GFA AIRWORTHINESS DIRECTIVE

TYPE AFFECTED: DG-1000S Serial no's: All

SUBJECT: Incorrect mounting of Horizontal Stabilizer.

Subject : Assembly of the horizontal tailplane
Manual revision

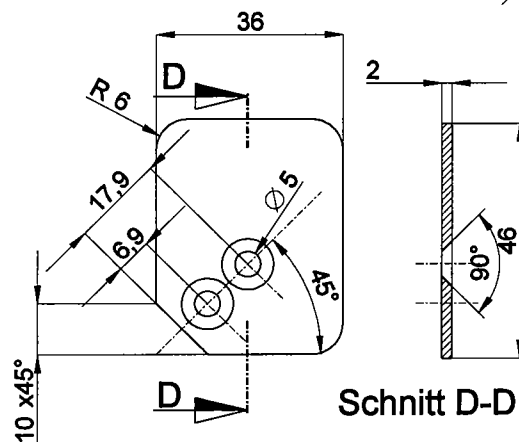
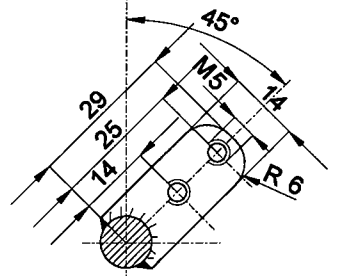
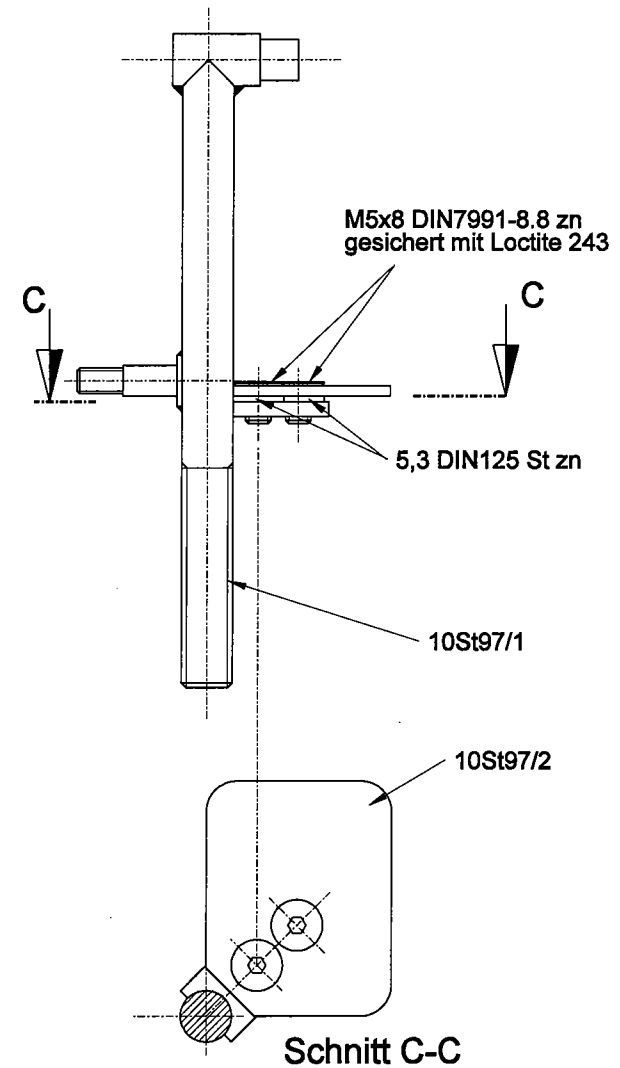
Reason : 1. A user succeeded in assembling the horizontal tailplane without connecting the elevator. A deflector has therefore been designed to prevent false assembly.
2. Manual revision due to service experience.

Instructions : 1. Remove the rod- end 5St94, see MM diagr. 1 (issued Nov. 2001), measure and note the distance between the axis of the brass roller and the upper surface of the counter nut prior to removal.
2. Ship the rod end 5St94 to DG for modification to part 10St97/1.
3. Install part 10St97/1. Check elevator deflections after installation and correct if necessary. Use a new selflocking nut M5 DIN985.8zn.
4. Install the deflector 10St97/2 to 10St97/1 according to drawing 10St97.
5. Exchange the placard on the fin (No. 16 see MM diagr. 11).
6. Manual revision: Exchange the following manual pages against new pages issued May 2004 marked with TN 413/3. Regard the changes.
a) Flight manual: 0.1, 0.3- 2.12, 3.2, 4.3
b) Maintenance manual: pages 0.2, 0.6, diagrams 1 and 11

Material : manual pages see instruction 6
drawing 10St97
10St97/1 modified from 5St94
10St97/2
2 washers 5,3 DIN125 St zn
2 screws M5x8 DIN7991-8.8 zn
selflocking nut M5 DIN985.8zn
Loctite 243
placard for the fin (No. 16 see MM diagr. 11)
